DESCRIPTIVE REPORT

Registry No. H-10966

General Locality West Coast of Kodiak Island

Project OPR-P312-RA-00 Larsen Bay and Approaches

Figure 3: H10966 Survey Junction

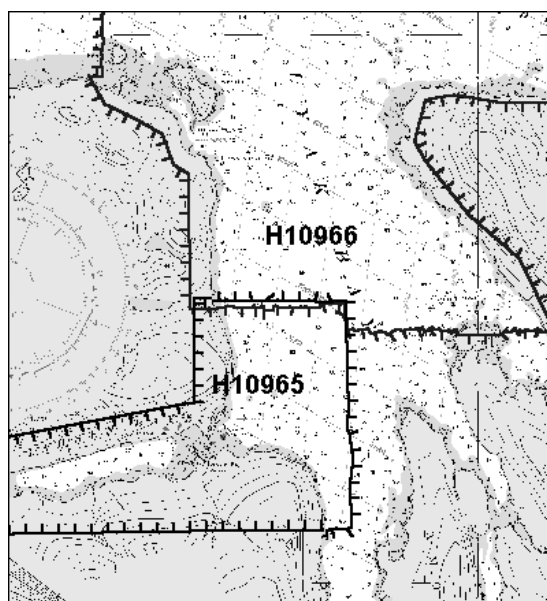
Survey H10965 junctions very well with this survey, with differences generally one fathom or less.⁹

Final comparisons will be made at the Pacific Hydrographic Branch (PHB) after the application of smooth tides.¹⁰

⁹ Concur

¹⁰ Concur. The junction with survey H10965 is complete. A "Joins" note has been added to the smooth sheet where applicable.
